# Access Compliance Report

## Public Rights-of-Way

### (Curb Ramps)

Intersection ID: 51519	Main Street: E_JOHN_BELK_RA	Cross Street: SOUTH_BV	Location: NW
ADA ID: BCA49456D01B	Ramp Type: Perp	Initial Pass/Fail: Fail	Overall Compliance: No
Severity Score: 12.5			
Codes/Mitigation Info/Possible Solution		Field Measurements/Component Compliance

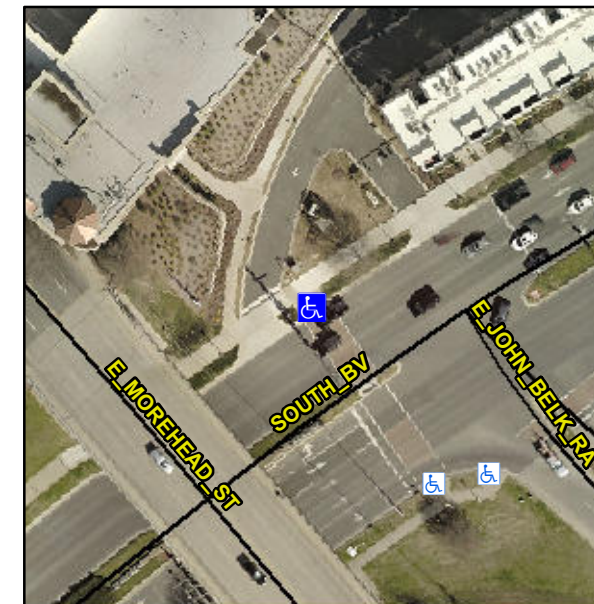
**Not Found, R304.2.2**

Compliance	Description	Data	Compliance	Description	Data
N/A	Ramp Length (in)	95.5	No	Ramp Slope (%)	8.6
Yes	Ramp Width (in)	48.0	Yes	Ramp XSlope (%)	0.3
N/A	Flare Type LT	N/A	N/A	Flare Type RT	N/A
N/A	Flare Slope LT (%)	N/A	N/A	Flare Slope RT (%)	N/A
N/A	Flare Traversable LT?	N/A	N/A	Flare Traversable RT?	N/A
N/A	Landing Length (in)	N/A	N/A	DWS Provided?	N/A
N/A	Landing Width (in)	N/A	N/A	DWS Contrast?	N/A
N/A	Landing Slope (%)	N/A	N/A	DWS Length (in)	N/A
N/A	Landing X Slope (%)	N/A	N/A	DWS Full Width?	N/A
N/A	Landing Curb? (Y/N)	N/A	N/A	DWS Offset (in)	N/A
N/A	Shared Landing?	N/A			
N/A	Gutter Ponding?	N/A	N/A	Gutter Slope (%)	N/A
N/A	Gutter Lip Ht (in)	N/A	N/A	Gutter X Slope (%)	N/A
N/A	Painted X Walk1?	Yes	N/A	Painted X Walk2?	N/A
	X Walk 1 Direction	To SE		X Walk 2 Direction	N/A
N/A	X Walk 1 Width (in)	185.0	N/A	X Walk 2 Width (in)	N/A
	X Walk 1 Slope (%)	3.2		X Walk 2 Slope (%)	N/A
	X Walk 1 X Slope (%)	0.2		X Walk 2 X Slope (%)	N/A

**Remove & Replace Entire Ramp.**
